## IRC TAG Existing Amendment Review

Last Updated: February 27, 2025

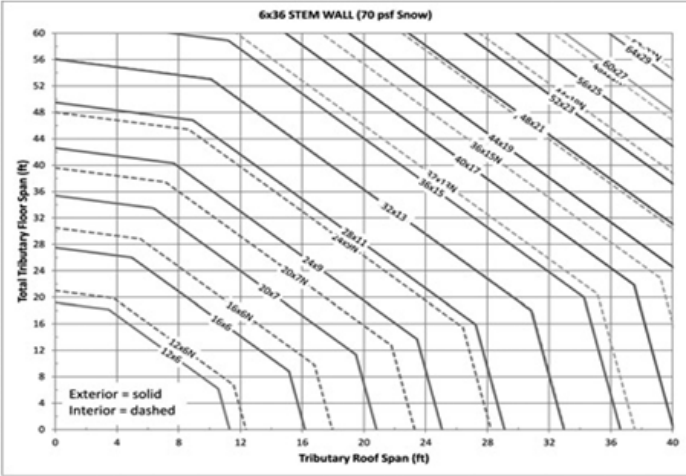
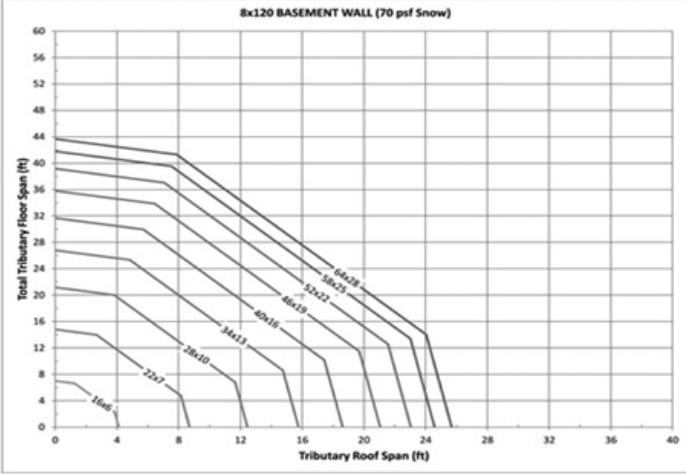
Footings	F R403.1.1(1)	F R403.1.1(1)		Keep Existing Amendment	Keep Existing Amendment	Discussed 7/31 Still using ASD not ultimate. Additional Discussion Needed.
